Staff Report

Infill Housing Design Review Committee

File Number: 12-D-24-IH

Location:	202 Hiwassee Ave.	Parcel ID
Zoning:	RN-2 (Single-Family Residential Neighborhood)	
District:	Oakwood/Lincoln Park Infill Housing Overlay District

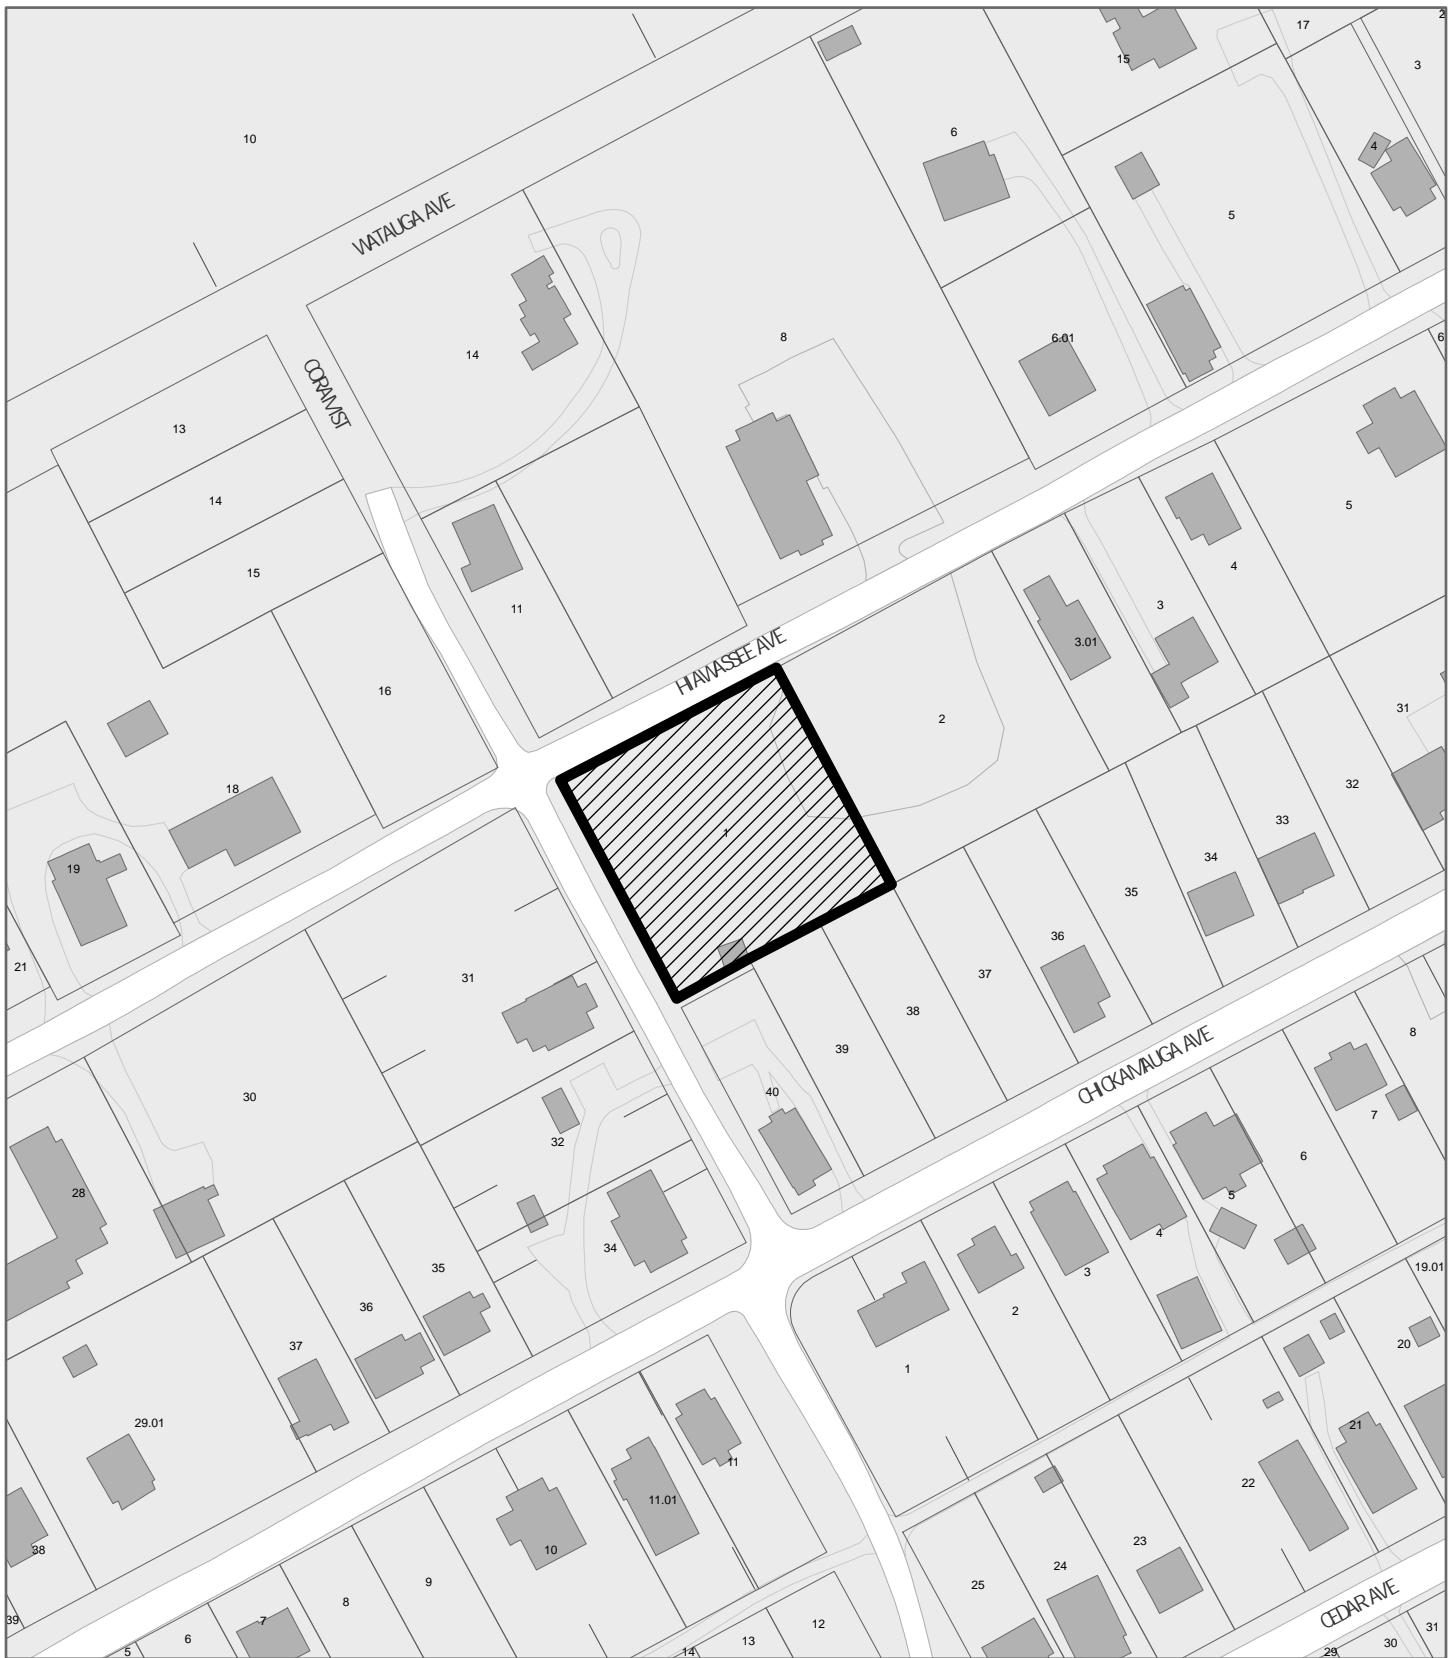
3. Infill Housing design guidelines recommend that on lots without alleys, new driveways should be at least 20' behind the front façade of the infill house with access limited to one lane between the street and the front façade. Parking is currently proposed for the front yard and should be revised to meet guidelines. The final site plan should meet City Engineering standards.

9. The site plan indicates a tree in the front yard, and the final site plan should also include a tree in the rear yard.

Front and Back Elevations

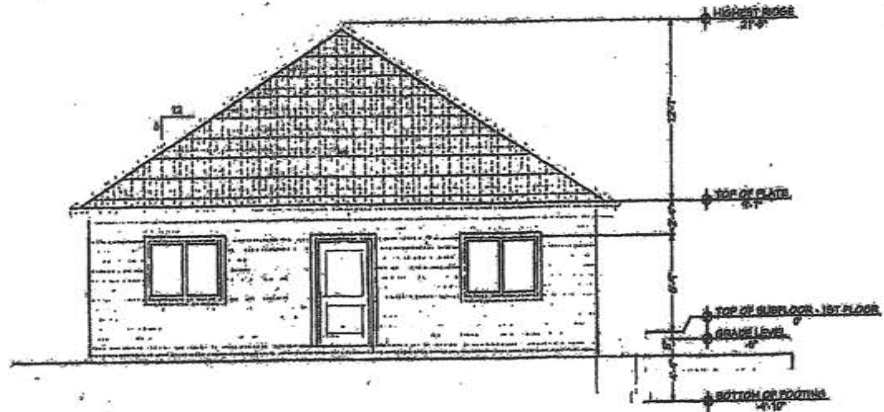
4. The three-bay façade is similar in scale and height to the context.

5. The design includes a 6' deep, half-length front porch recessed under the primary roofline, supported by two square columns with a base and shaft made from an unspecified material. Guidelines typically recommend a porch 8'-12' deep. The porch depth should be revised to meet guidelines.

6. Guidelines recommend window and door styles be similar to historic houses on the block, with similar placement and ratio of solid to void, and also note that "contemporary windows such as 'picture windows' should not be used." The design primarily uses paired picture windows, which are incompatible with the context where 1/1 single-hung windows are most common. The front and rear elevations contain sufficient transparency. The right elevation contains one paired picture window, and the left elevation features a single-hung window and a small picture window. Picture windows should be revised to be single-hung, and one window should be added to the right and left elevations, with details submitted to staff for approval.

Staff recommends approval of Certificate 12-D-24-IH, subject to the following conditions: 1) final site plan to meet City Engineering standards; 2) modifications to the porch to meet Infill Housing guidelines; 3) use of lap siding with an overlap instead of Dutch lap or flush panel siding; 4) final site plan to include a walkway from the front door to the street; 5) revisions to parking to meet design guidelines and avoid the front yard; 6) revisions to façade and side elevation windows design and placement, with approval by staff; 7) final site plan to include one tree in the front and rear yards.
